ARCHITECTS'S FIELD REPORT

STATE PARK	Arkansas State Parks	Notice to Proceed – 27 July 2021	
	Lake Dardanelle State Park	100 Contract Days to 26 Sept 2002	
Project	Visitor Information and Education Center	25 July 2003 Substantial Completion Date	
Contractor:	Johnson Engineering, Inc.	Phone	
Office Contact	Don Johnson	Phone	
Project Manager		Phone	
Job Superintendent		Phone	
Architect / Engineer	The Borné Firm Architects, P.A.	Phone	
DBA Inspector		Phone	
DBA # 0003.15		Contract Amount \$2,297,000.00	
State Park# 07BF98103			
Date of Visit	2022-08-09		
Friday, Aug 9, 2022	Weather Condition	sunny	Temp: 90°
	People on site – 5

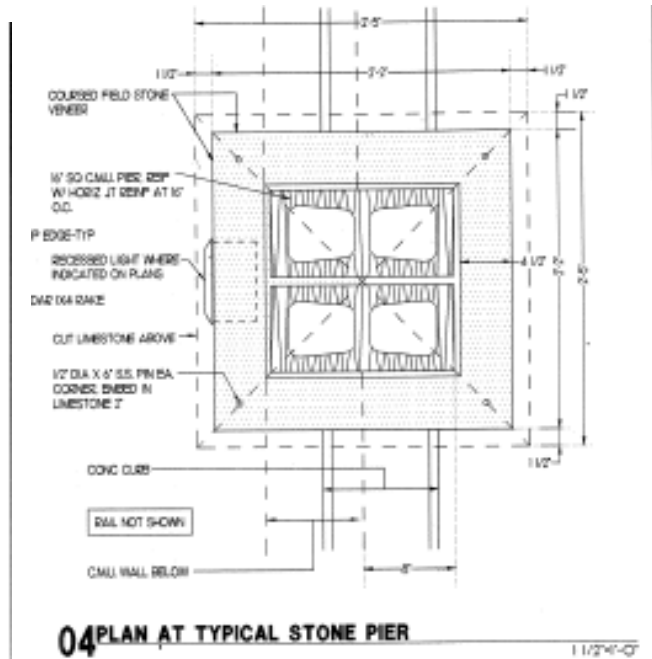
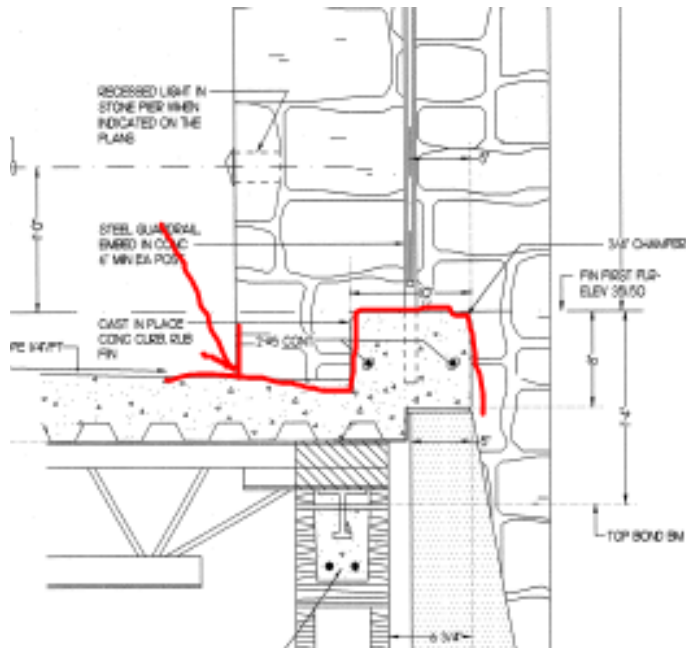
Below is a photo of the column at the observation deck with the construction section for the column to the right. There was no flashing at the top of the column, and the weather coming off the lake wasn't taken into consideration that water would get to area, but it has and over the years that has caused rot at the column, with water evidence being seen at the underside of the decking in this area where it has been dripping down to the crawl space. Work is in progress to add flashing to the top of these columns.

At the short columns at the perimeter of the observations deck, there is water coming through them. I'm not finding in the drawings any verification that the cast in place concrete curb that I have outlined in red below is continuous through the column. The detail of the column to the right does suggest that the curb is not continuous. What is now happening is that water is getting behind the rock and making its way down to the crawl space. A solution for this may be to add a bead of caulk along the base of the rock, where it meets the concrete deck (indicated by the red arrow.)

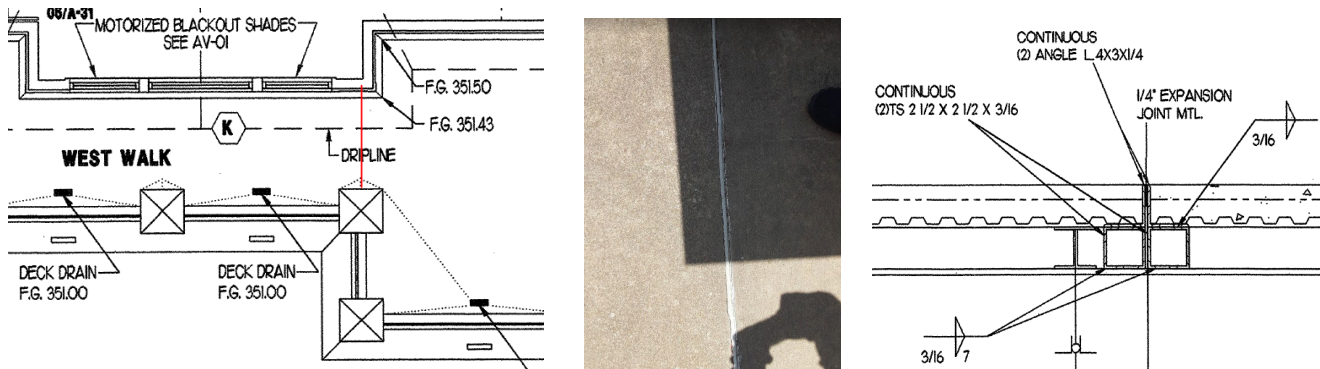
At the transition between the west walk and the observation deck, floor plan for reference, there is a construction joint that doesn't show up in the drawings, shown in red. The support joist change directions at this point, so this detail is similar to another detail that is shown on the drawings. The water seepage to the crawlspace may be the greatest at this point, and the joint needs to be maintained with the proper caulking process on a regular basis. It was done by a contractor approximately five years ago.

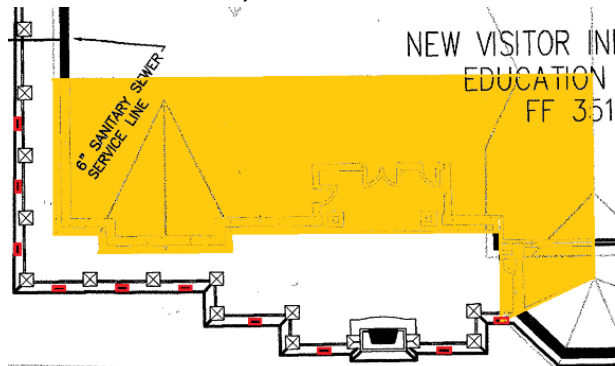
About thirty percent of the roof drains onto the observation deck and the west deck and there are no gutters. I propose gutters that will have a down spout that is cored through the deck and then connects with the existing wall spout to drain to the exterior. Do to the volume of water and the size of the existing outlets, we will need to size a holding pipe to control the flow to the exterior while being able to contain the volume of water that is coming off the roof.

The area shaded in yellow is the area that drains to the observation deck and the west walkway, with the existing drains at the deck shown as the red squares.

This is where I'll do the calculations to determine the volume of water that is coming off the roof and the size and number of the down spouts needed.

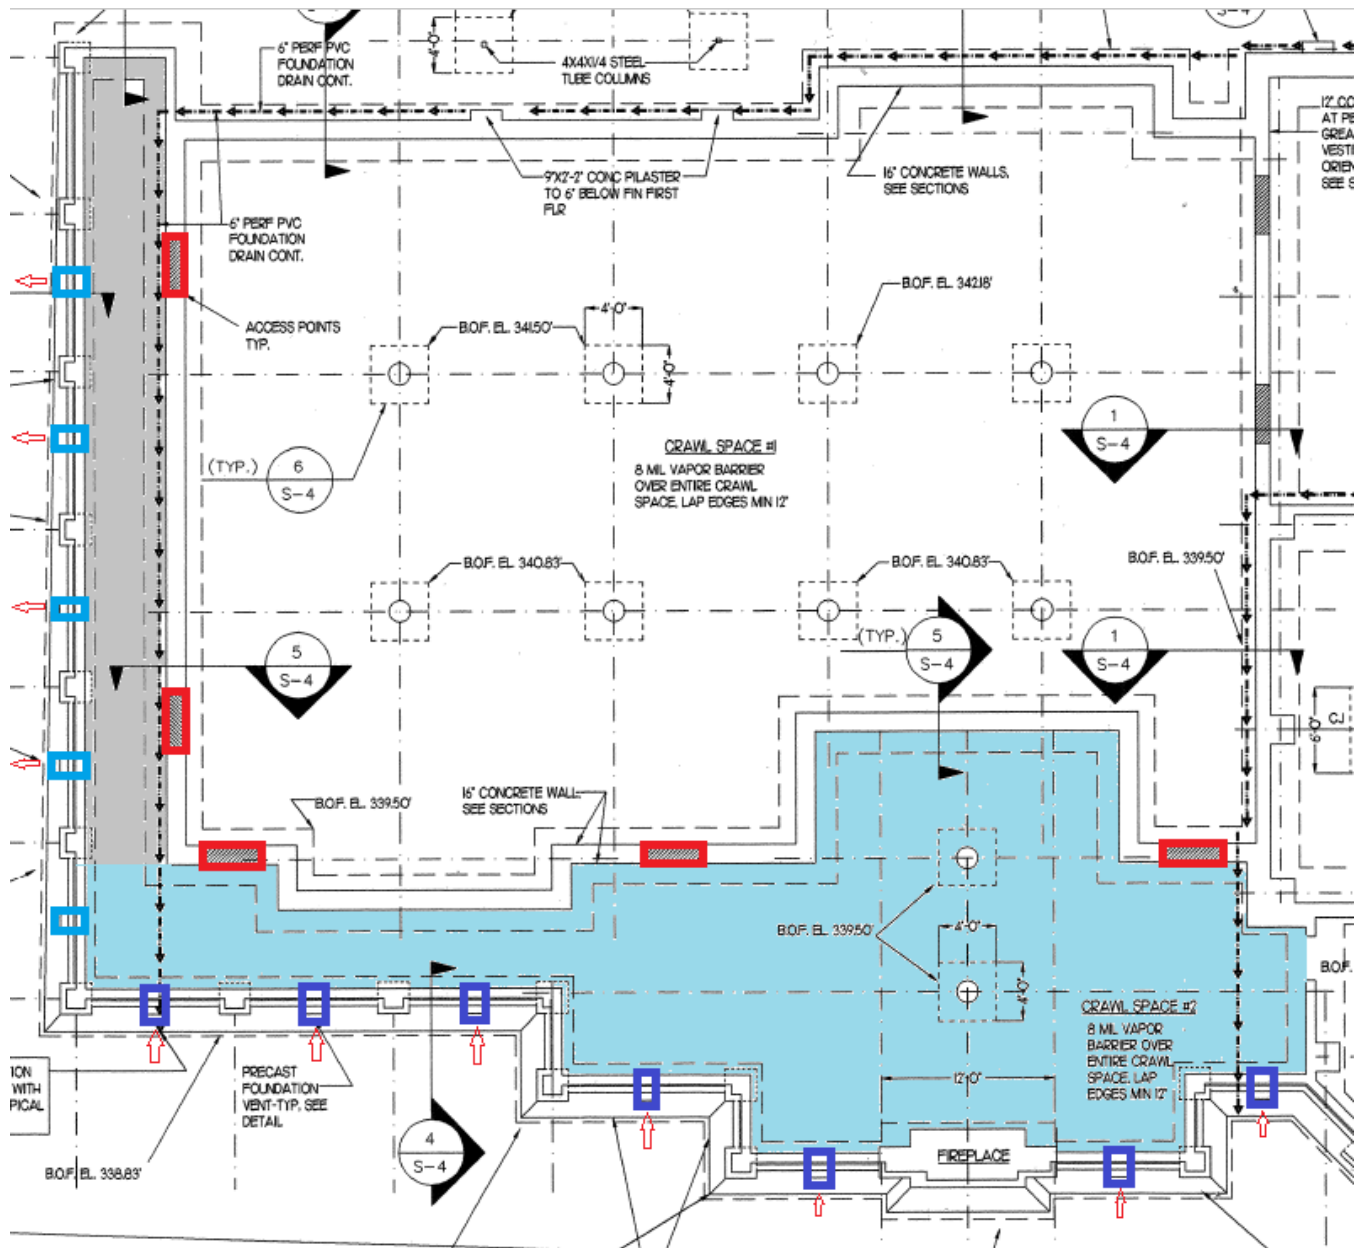
At the crawl space the plans called for all areas to have an 8 mil vapor barrier, but at the area colored light blue in the image below, there is only exposed dirt. The area shaded in gray, has the vapor barrier as well as gravel. The light blue area needs to have the vapor barrier installed as well as a layer of gravel. Also on this image, the darker blue squares on the left of the plan are the ventilation openings with the decorative grill that is seen at the exterior. To reduce the amount of moisture in the crawl space, exhaust fans could be installed at the vents under the north walk. This would draw air from the vents on the west side to ventilate the space. There are several openings to the greater part of the crawlspace that would need to be covered up with a simple frame and plywood to minimize air being drawn from those areas. The openings are show below as red squares.

Photo: beam to outer wall to north of fireplace.

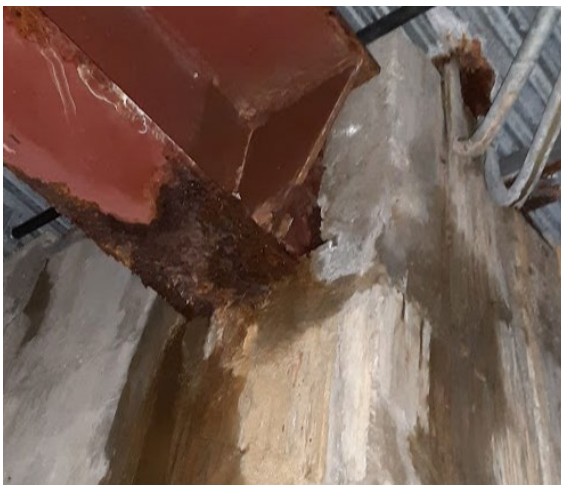
The rust that is seen at the underside of the decking needs to be dealt with by removal, cleaning, and primer
